Safety Recall

N242441391 Left Side Seatbelt Retractor May Lock

Revision: 01

Revision Description: This bulletin is being revised to update the inspection steps in the service procedure. Please discard all previous copies of bulletin N242441391.

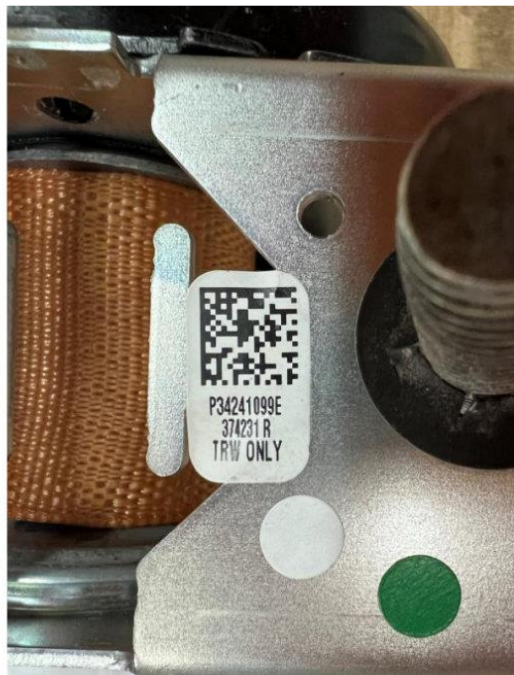
Important: DO NOT install the replacement Seatbelt Retractor if they fail one or both inspections below.

1. Inspect the NEW Seatbelt Retractor label located on the bottom of the Seatbelt Retractor.
 - If the 4th and 5th digits are "23" AND the 1st and 2nd digits range between "35"-"52", The part is BAD and MUST be scrapped. DO NOT INSTALL ON VEHICLE. Reference the Scrap Instructions below. Re-order a replacement Seatbelt Retractor and repeat inspection.
 - If the 4th and 5th digits are "23" AND the 1st and 2nd digits DO NOT range between "35"-"52" proceed to Step 2.

2. Continue to inspect the NEW Seatbelt Retractor label located on the bottom of them retractor.
 - If the 4th and 5th digits are “24” AND the 1st and 2nd digits are “01”, The part is BAD. DO NOT INSTALL ON VEHICLE. Re-order a replacement Seatbelt Retractor and repeat inspection.
 - If the 4th and 5th digits are “24” AND the 1st and 2nd digits are NOT “01” proceed to Step 3.
3. Replace the LH Front Seat Belt Retractor. Refer to *Front Seat Belt Retractor Replacement* in SI. If convertible, refer to *Front Seat Belt Retractor Replacement - Left Side (Convertible)* in SI.
4. Scrap all replacement Seat Belt Retractors that failed inspection steps 1 and/or 2 AND the used Seatbelt Retractor. Refer to the Scrap instructions below.
